SERVICE BULLETIN

SERVICE BULLETIN		No.: MSB-99E23-503	
		Date: 1999-12-15	<Model> <M/Y>
Subject: CHANGES IN AND CORRECTION TO FRONT WHEEL DRIVE A/T WORKSHOP MANUAL		(EC) SPACE WAGON (N84W)	99-10 99-10
Group: AUTOMATIC TRANSAXLE	Draft No.: 99TA532317		(EC) GALANT (EA0)
CORRECTION	INTERNATIONAL CAR ADMINISTRATION OFFICE	<i>Tomoki Nitta</i> T.NITTA - PROJECT LEADER AFTER SALES SERVICE & CS PROMOTION

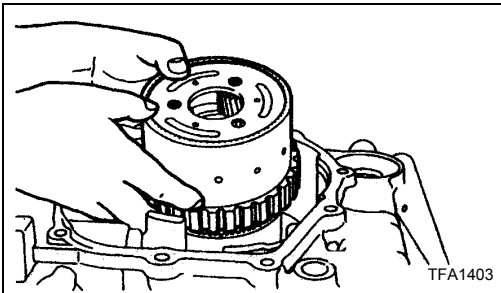
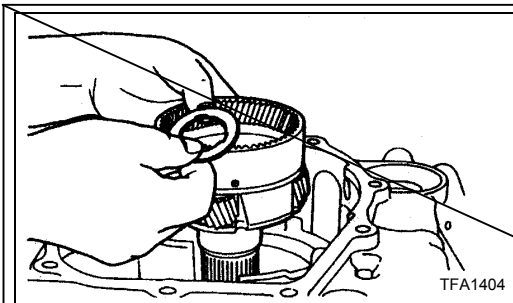
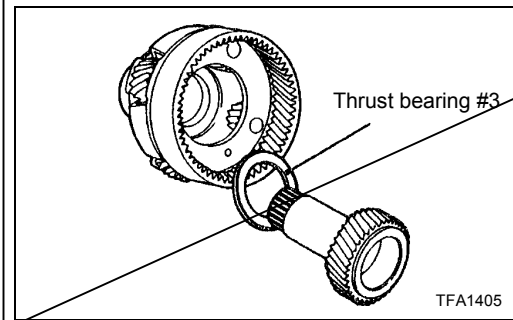
(46) Remove the ~~overdrive planetary carrier~~. **<Incorrect>**

<Correct>

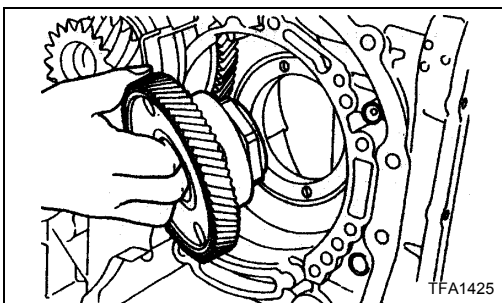
(58) Remove the transfer drive gear mounting bolts (4 pieces – F4A41 • F4A42, 8 pieces – F4A51). **<Incorrect>**

Remove ~~four~~ mounting bolts. Then, turn the gear 1/8 turn (45°) and remove the remaining ~~four~~ bolts.

<Incorrect> **<Incorrect>**

Four or three **<Correct>**

7 <Correct>

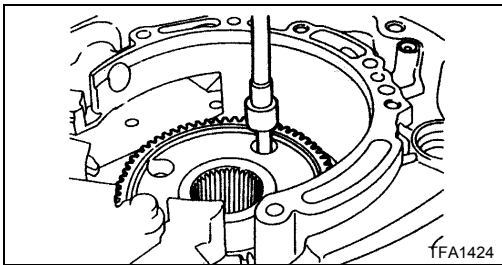
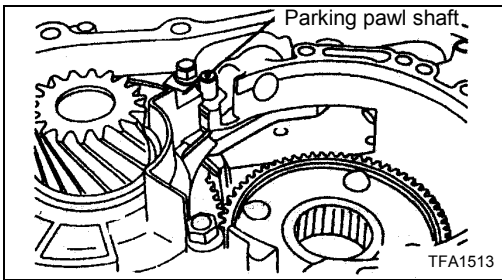
Modification D: On some models equipped with the F4A42 transmission, the number of the transfer drive gear mounting bolts has been changed from 4 to 7.

Modification E: On some models equipped with the F4A51 transmission, the four bolts for mounting the transfer drive gear have been corrected to the eight bolts.

(23) Tighten the ~~four mounting bolts~~ of the transfer drive gear to the specified torque. **<Incorrect>**

Seven mounting bolts (F4A42) and eight mounting bolts (F4A51)

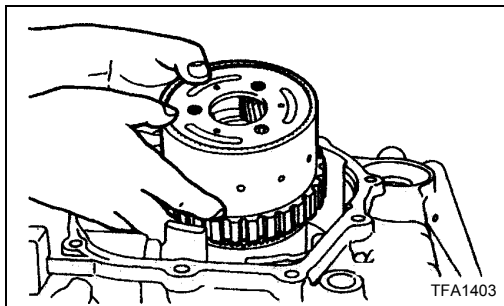
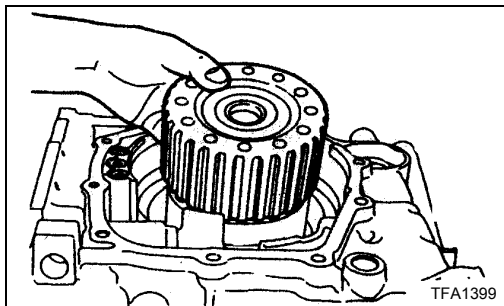
(28) Install the ~~overdrive planetary drive~~

<Incorrect>

Planetary carrier assembly

<Correct>

**7. OVERDRIVE PLANETARY CARRIER
DISASSEMBLY AND REASSEMBLY**

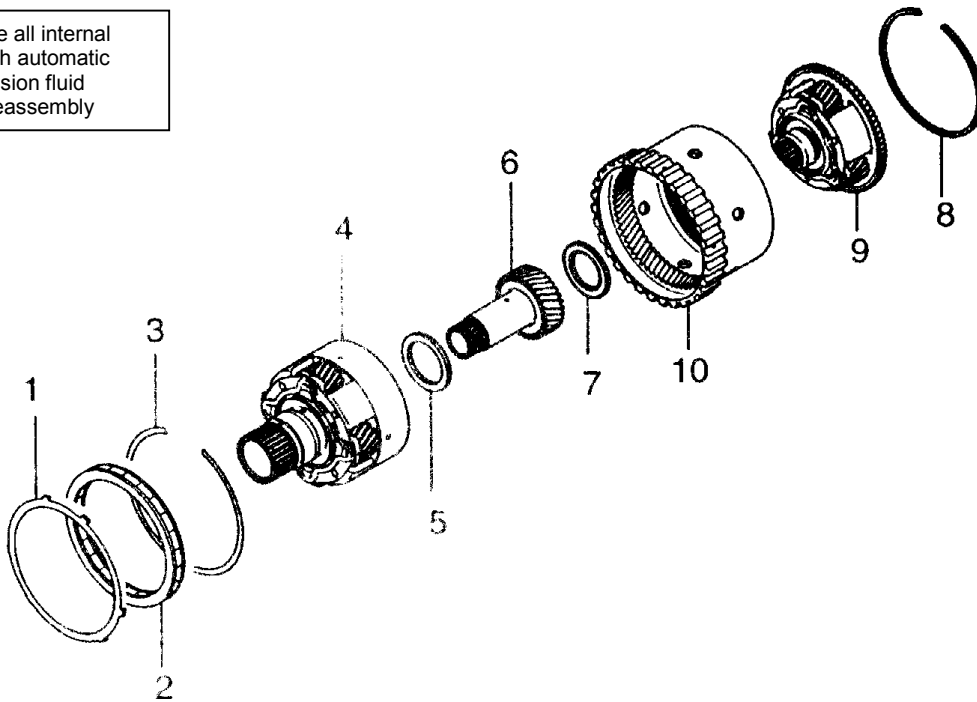
<Replace by the following page>

7. PLANETARY CARRIER ASSEMBLY DISASSEMBLY AND REASSEMBLY

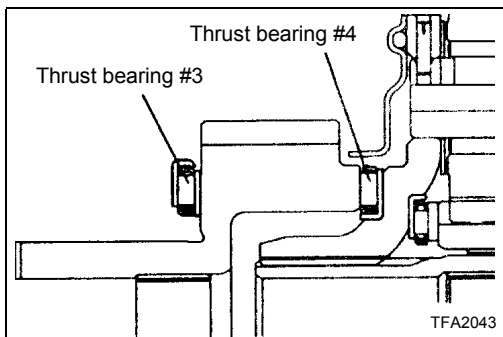
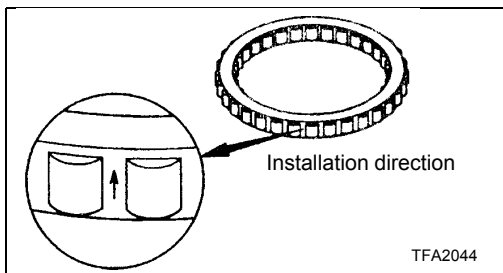
1999 transmission models (F4A42 with one-way clutch for 2.4-liter and 2.5-liter engine equipped cars) added.

- ▶B◀ 1. Stopper plate
- ▶B◀ 2. One-way clutch
- ▶B◀ 3. Snap ring
- ▶A◀ 4. Output planetary carrier
- ▶A◀ 5. Thrust bearing #3

- ▶A◀ 6. Under drive sun gear
- ▶A◀ 7. Thrust bearing #4
- ▶A◀ 8. Snap ring
- ▶A◀ 9. Over drive planetary carrier
- ▶A◀ 10. Over drive annulus gear

Insert the one-way clutch into the over drive annulus gear so that the arrow points to the output planetary carrier side.
